Prepared for St. Luke's Grammar School
September 2020

SSDA Response to Submission (RTS)

New Senior School Campus

800 Pittwater Road, Dee Why NSW 2099

3.1 Alternative Vehicle Access to 800 Pittwater Road

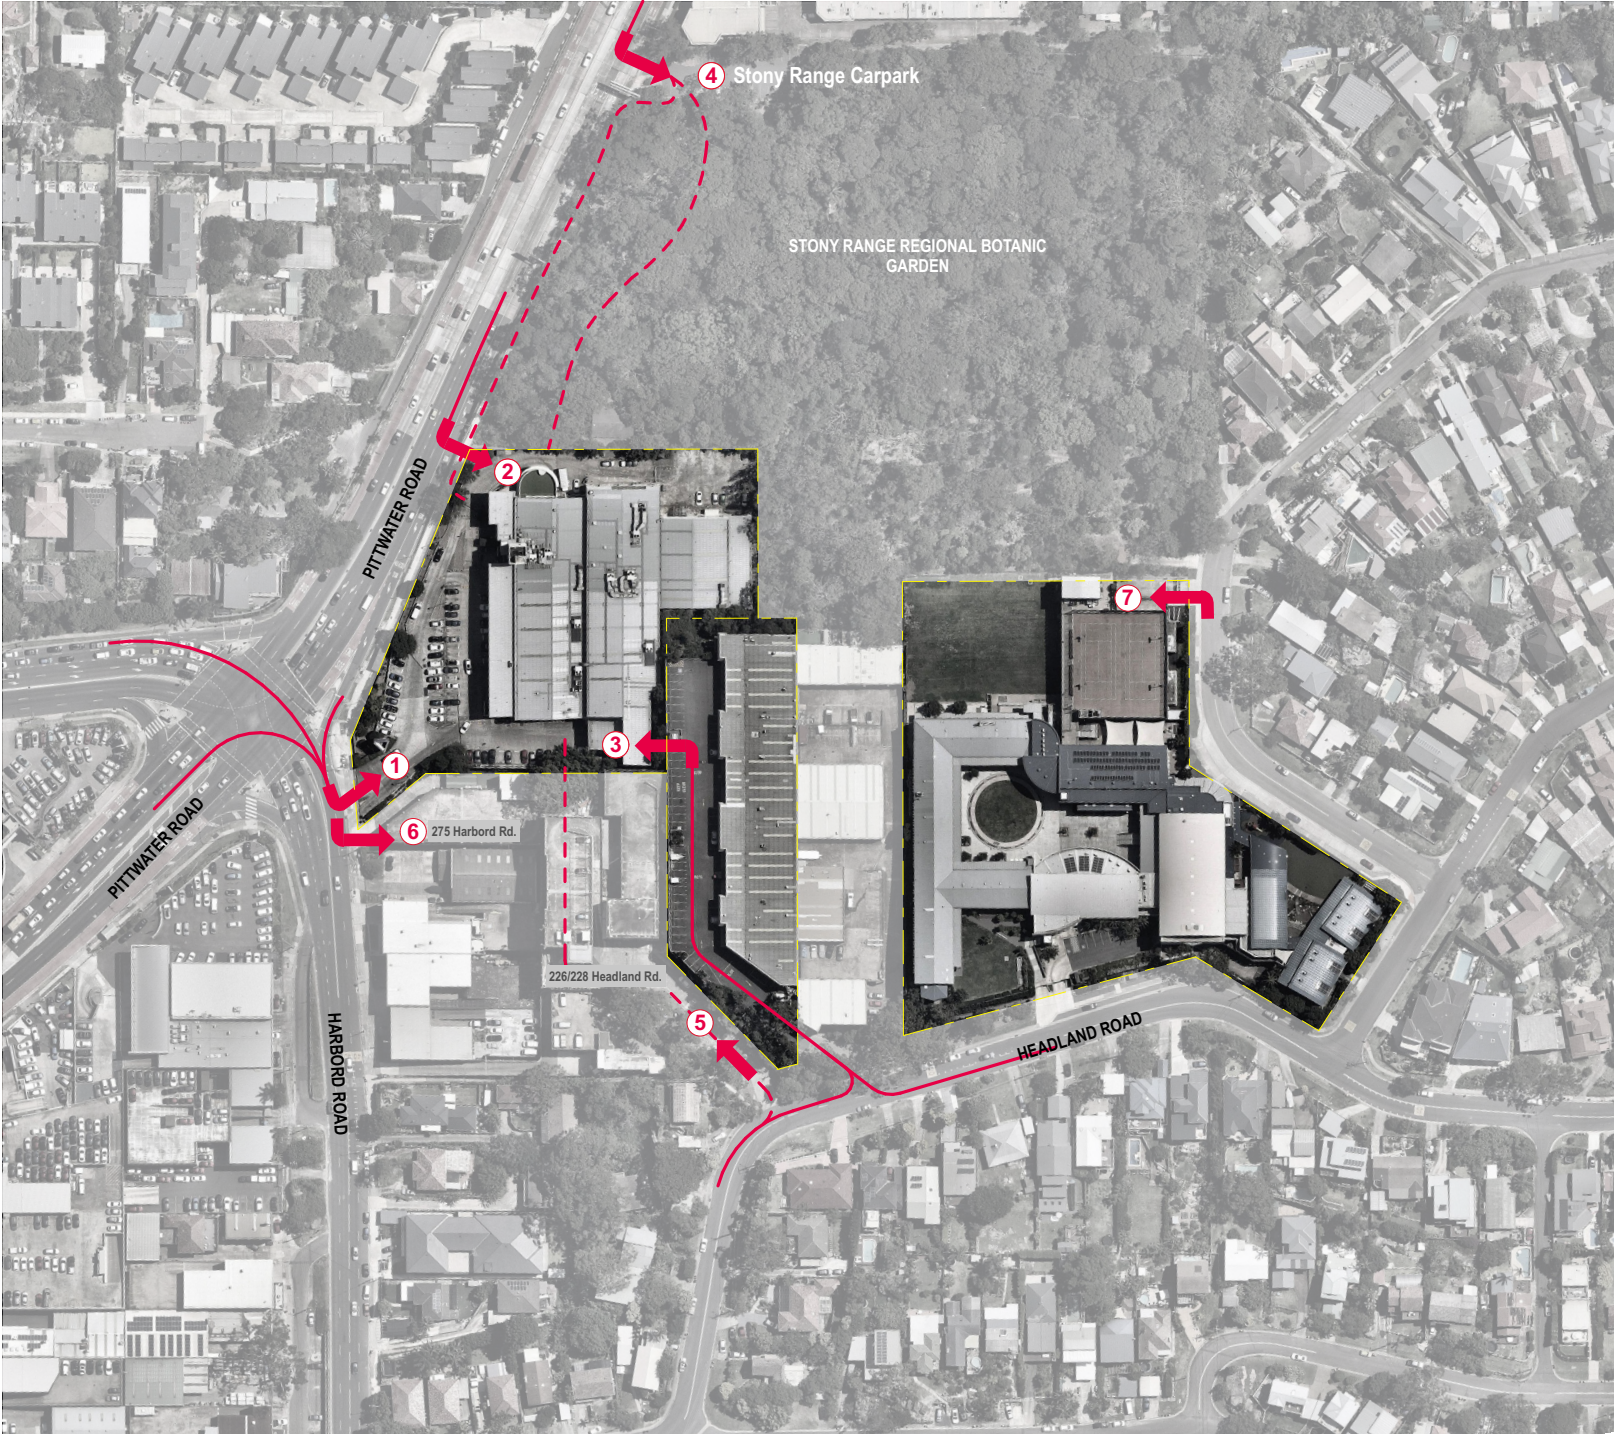
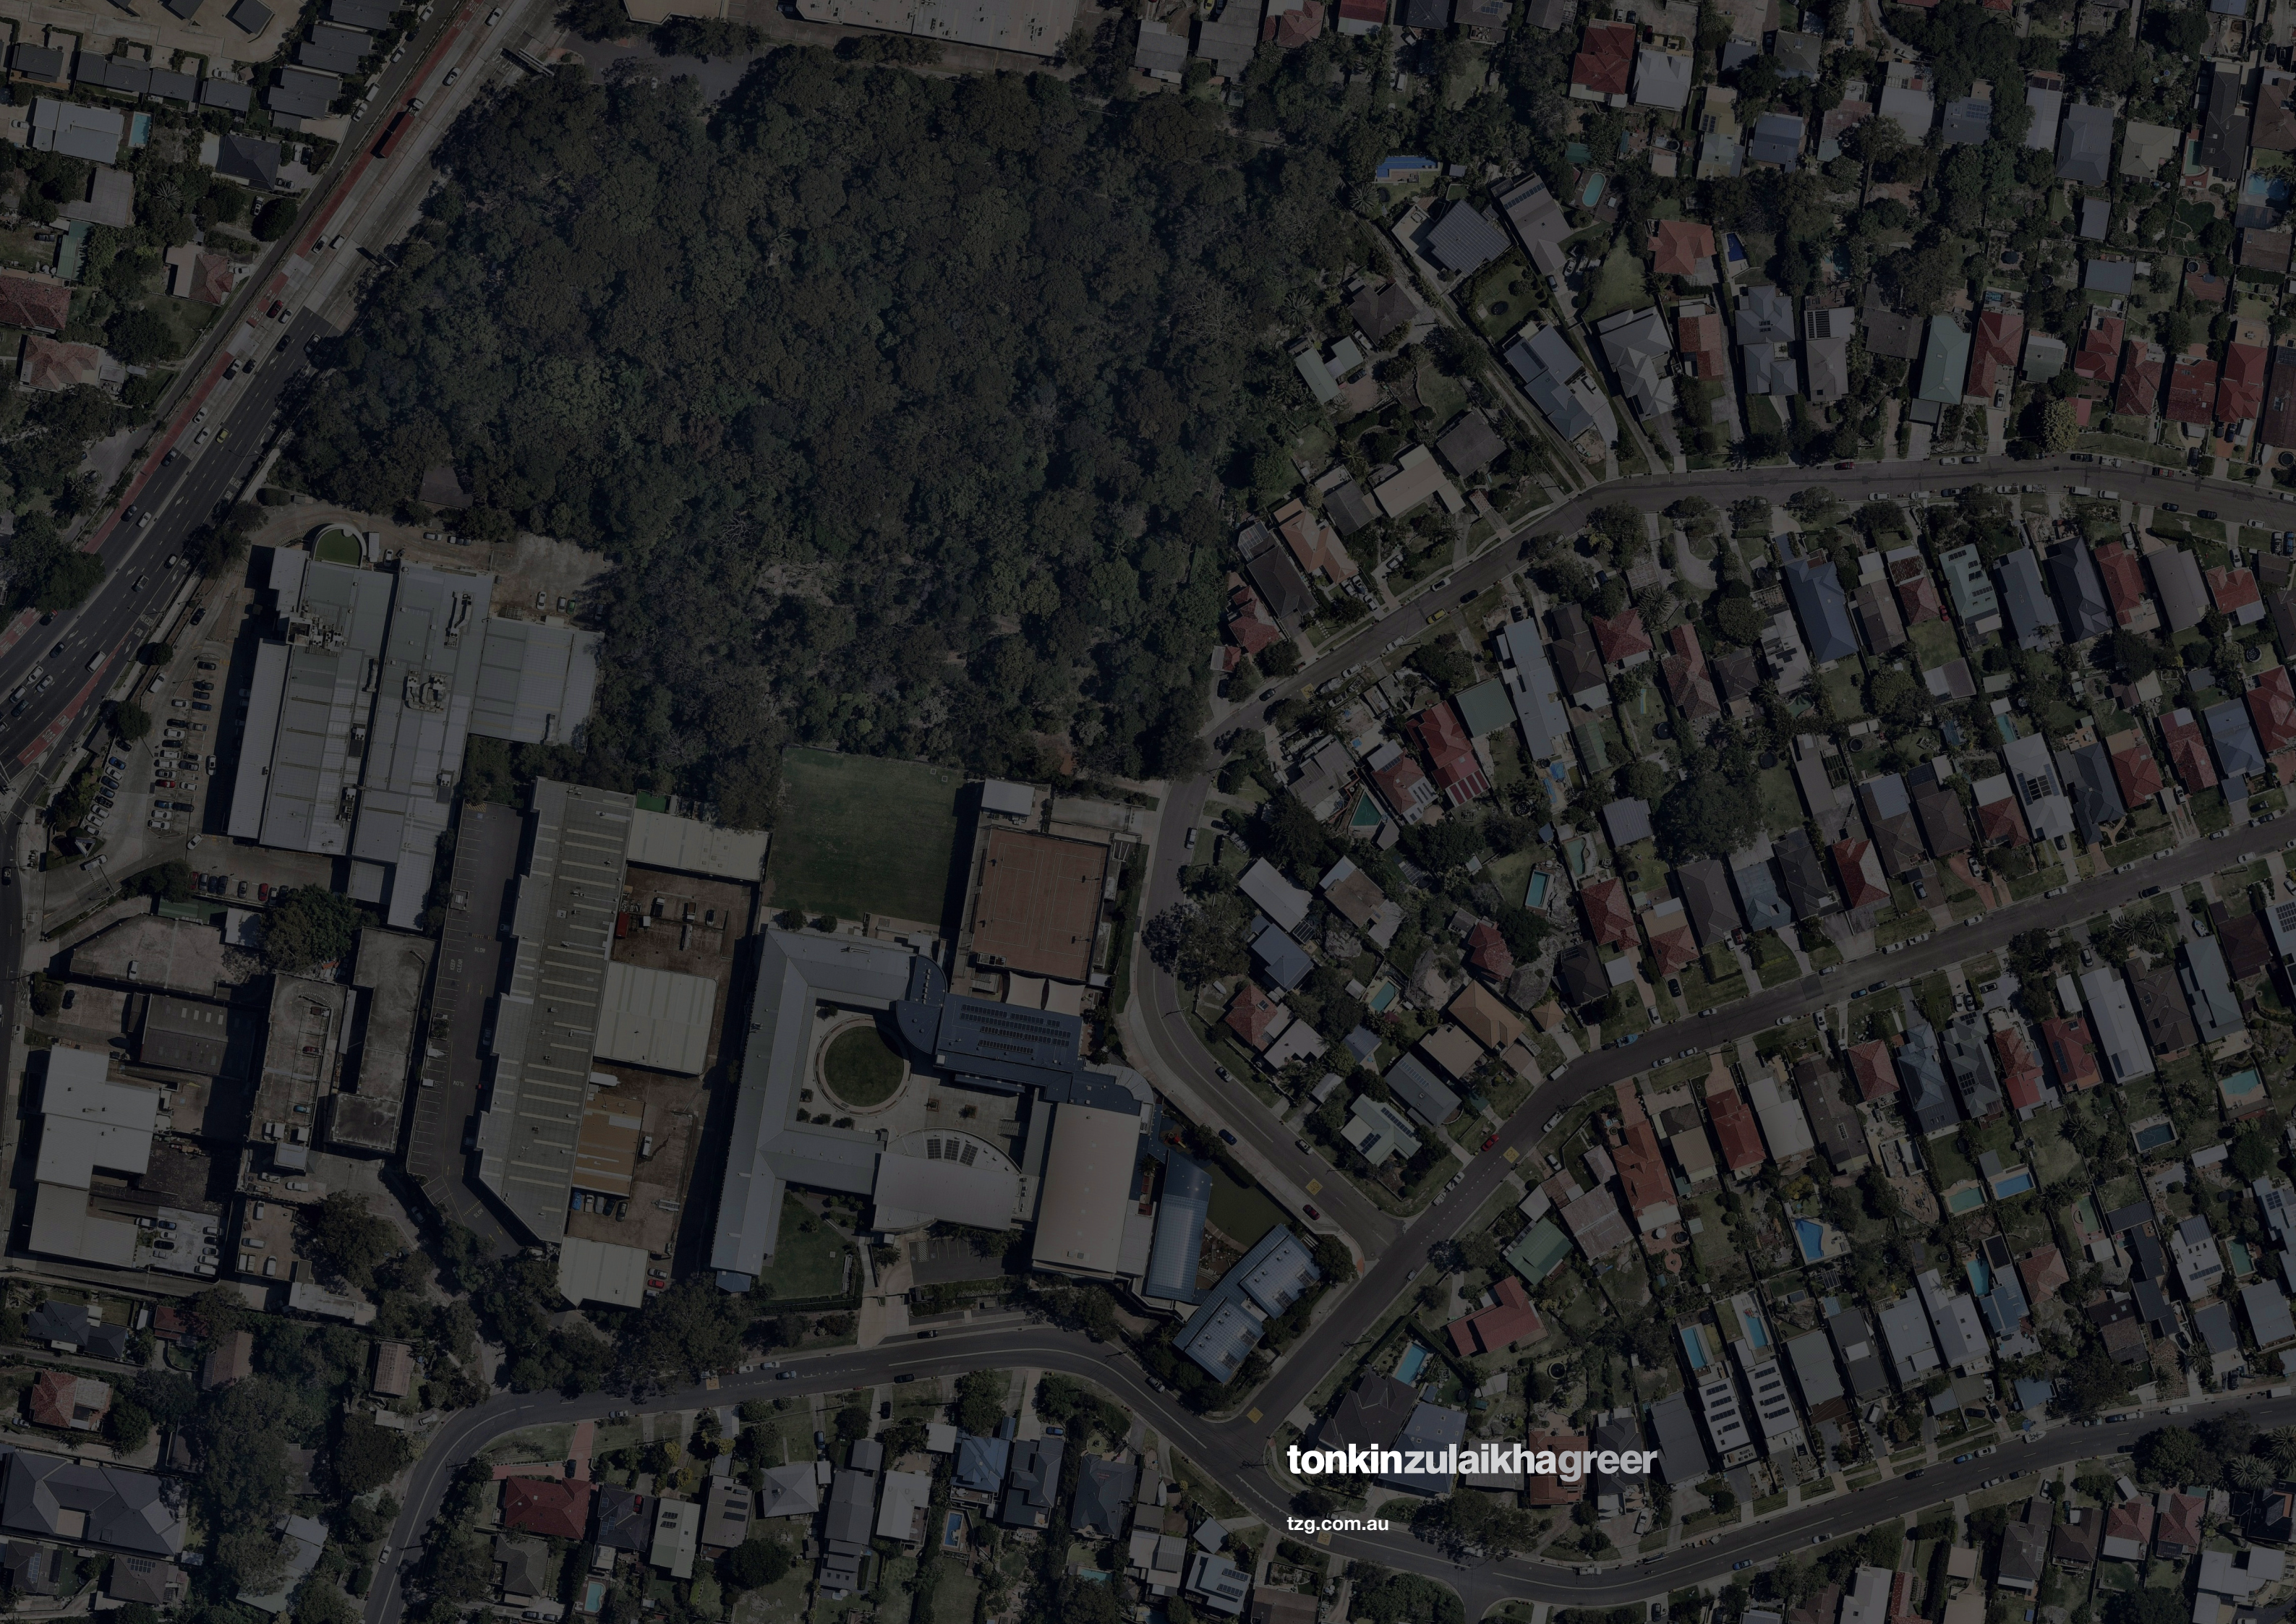
The preference of Council is that the access be provided on Pittwater to avoid the potential of rear end collisions when turning from Pittwater Road onto Harbord Road, being that the access point is close to the intersection.

An access directly off Pittwater Road would provide better accessibility and improve safety. Further, the reconfiguration would support the possibility for additional parking capacity.

- The proposed activities associated with the development would likely to increase pedestrian / vehicle conflicts and cause pedestrian related incidents at the entrance to the school with the increase in pedestrian movements. and
- The proposed school arrangement would have potential impact on the safety and operation efficiency of the Pittwater Road / Warringah Road signalised intersection as the proposed school activities such as off-street parking and pick up and drop off activities on site would likely to cause queuing onto Harbord Road, which results in immediate obstruction to the operation of the signalised intersection. As such, Transport for NSW does not support the vehicle access driveway from Harbord Road to the proposed development.

- Investigates an alternate access to Harbord Road driveway with the closure of this access in consultation with TfNSW during the preparation of the applicant's response to submission.

- investigate the feasibility of an alternative access point to the site, including the closure of the Harbour Road driveway. Or
- demonstrate that the existing driveway can operate safely in the future ameliorating the identified risks.
